January 30, 1975

Subject: Complaint issued by Mrs. Mary Sauber at  
204 Filmore St. for possible violation  
of City Ordinance No. 464 at 202 Filmore  
St.

SKETCH SHOWING  
THREE APPROVED METHODS  
OF DISCONNECTING DOWNSPOUTS  
FROM SANITARY SEWERS. ALSO,  
APPROVED METHOD OF HANDLING  
STORM AND SURFACE WATER IN  
NEW CONSTRUCTION.

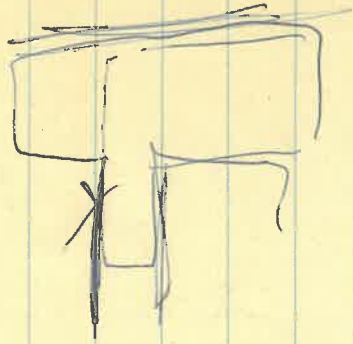
1. On the Northeastern side of the dwelling, the down-  
spout is not properly installed to handle water  
drainage.
2. The present installation is also a hazardous con-  
dition because of its location near a means of  
egress in case of a fire.

Therefore, you must comply with any one of the three  
approved methods noted on the attached sketch within fourteen  
(14) days from the date of this notice or the City of Napoleon  
will have no other alternative but to enforce the penalties  
set forth in Section 6 and 7 of City Ordinance No. 464.

Mr. Wenner changed routing  
of downspouts on week-in of  
1/25/75.
